Revised January 27th, 2022

Site: 166 Lyell Street, Los Altos CA

As requested on Thursday, September 10th, 2020, and again on January 21st, 2022 I visited the above site for the purpose of inspecting and commenting on the trees. A new home with a basement is proposed on site, and your concern as to the future health and safety of the existing trees has prompted this visit. A tree protection plan will be found within this report to protect the retained trees from construction. The entire 36 page planning submittal package has been reviewed.

Showing the recommended tree protection fencing placement

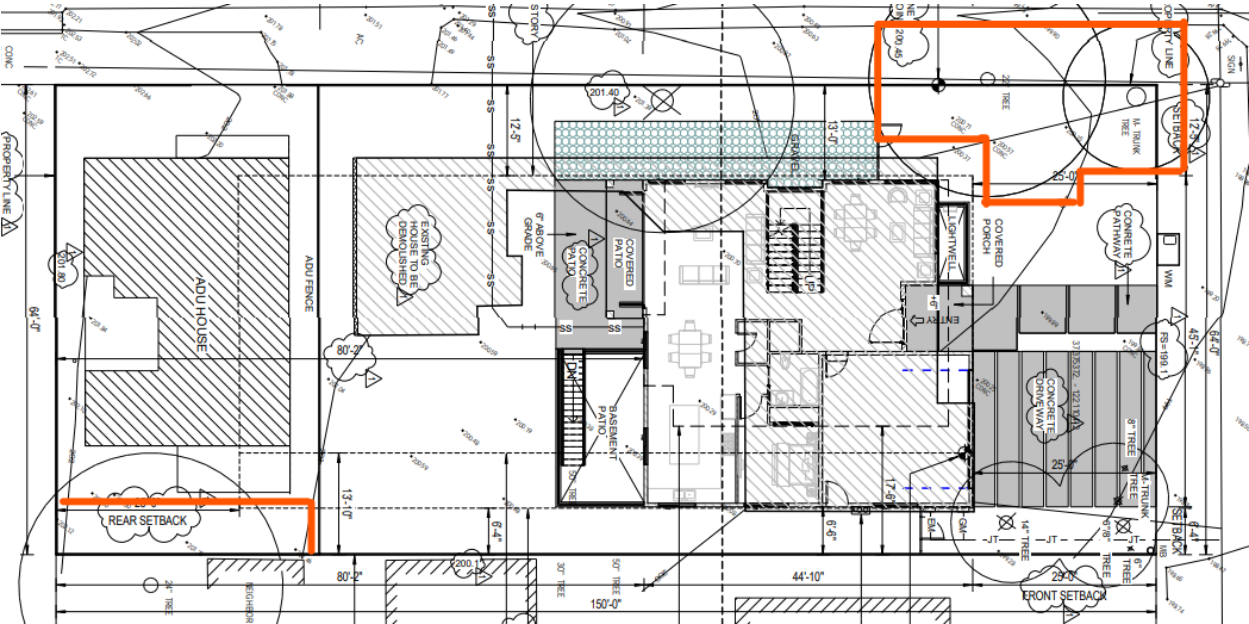
Tree protection fencing for the neighbor’s oak tree #10 should be 6-foot-tall metal chain link type supported by 2 inch metal poles pounded into the ground by no less than 2 feet. The support poles should be spaced no more than 10 feet apart on center. The fencing must extend off of the property line fence out to a distance of 3 feet from the proposed ADU or 15 feet from the tree whichever is further from the tree.

Birch tree #8 will need to have tree protection fencing located 12 feet from the tree where possible.

Pine tree #9 will need to have tree protection fencing located at 3 feet from the proposed basement cut, and out to 15 feet from the tree wherever else possible. Below is a diagram showing the recommended placement of the tree protection fencing.
